4.3 Trail Improvements Plan

Far North Bicentennial Park Trail Improvement Plan
January 2008 Meeting Notes

Public Comment Summary

Figure 26
Trail Trunk System

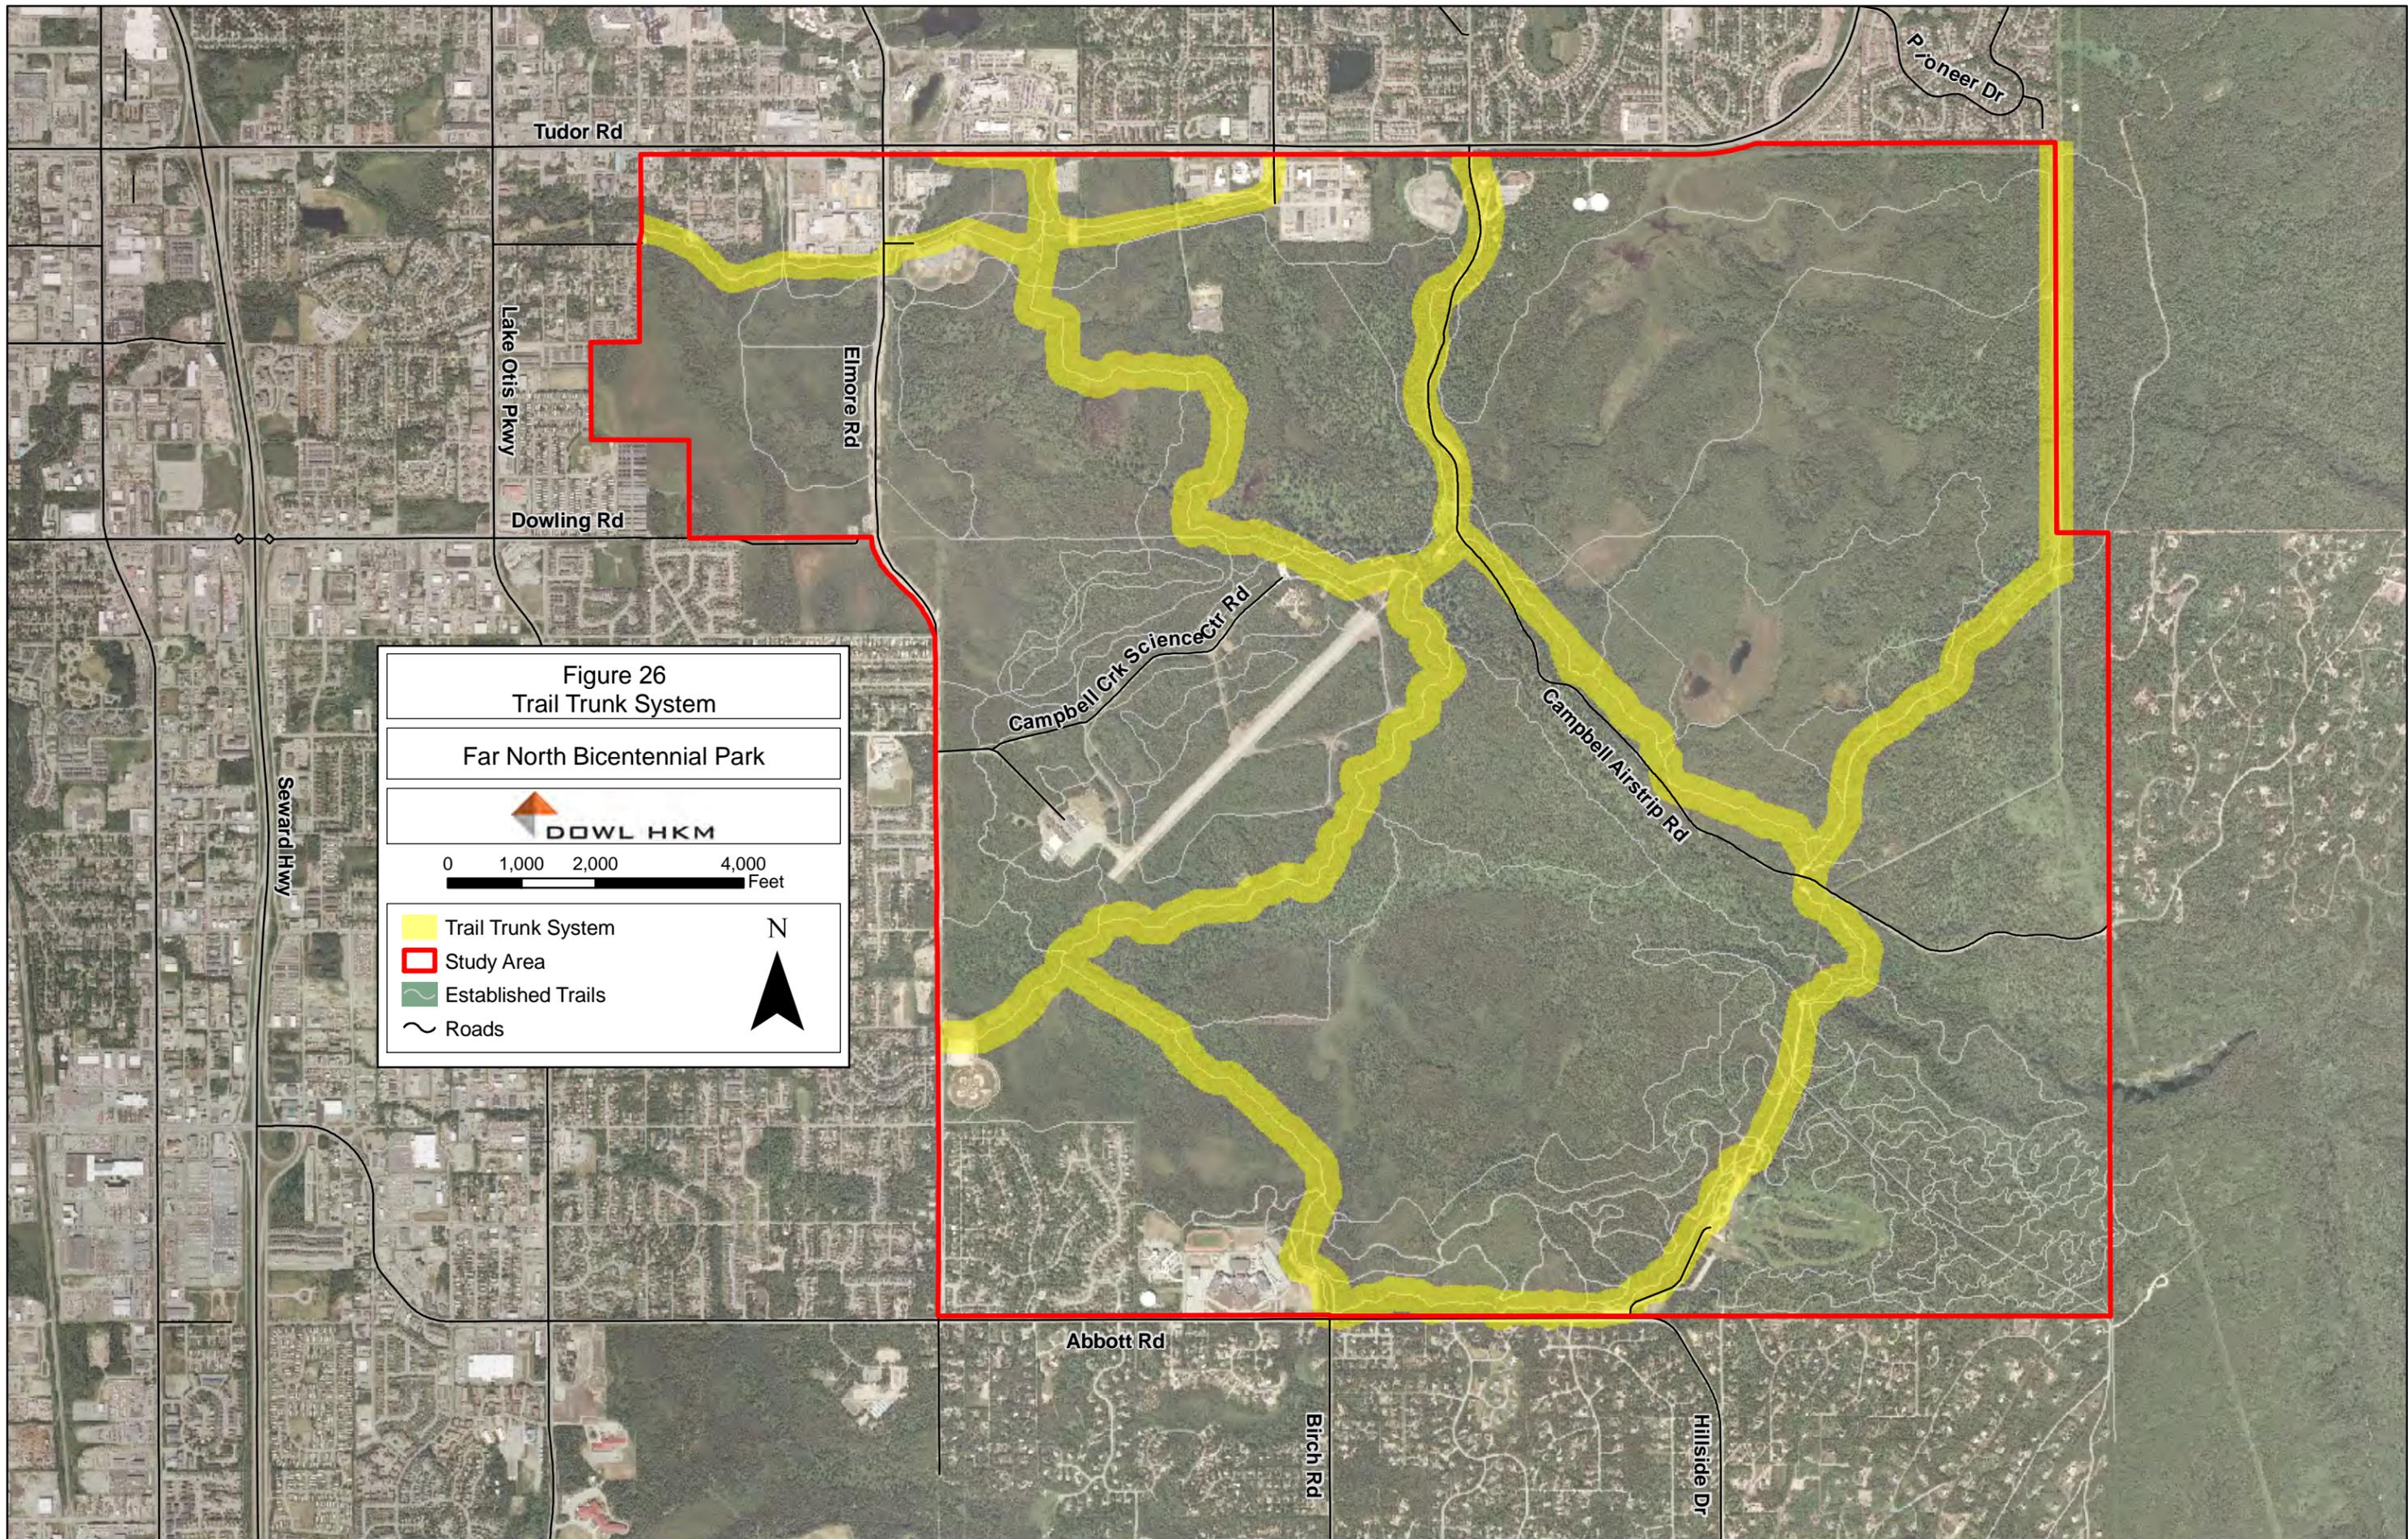
Support this project.	Erik Schoen	Acknowledged.
	Not clear that any tread work south of the second bridge is also included.	Jack Mosby	Figure 26, page 68 shows the extent of the project – from the north boundary of the BLM property north to the Dr. Martin Luther King, Jr. Avenue intersection.
	Support the additional gravel fill eliminating current mud holes and improving tread.	Scott Digert	Acknowledged.
	Strongly support additional gravel fill from edge of BLM trail improvements at the south Campbell Creek bridge to eliminate mud holes and improve the tread.	Bill Bredar	Acknowledged.
	...hope this includes hardening of the trail on both the north and south side of the Campbell Creek Bridge.	Kathy Faryniarz	Figure 26, page 68 shows the extent of the project – from the north boundary of the BLM property north to the Dr. Martin Luther King, Jr. Avenue intersection.
Project #4	Dog Mushing Bridges
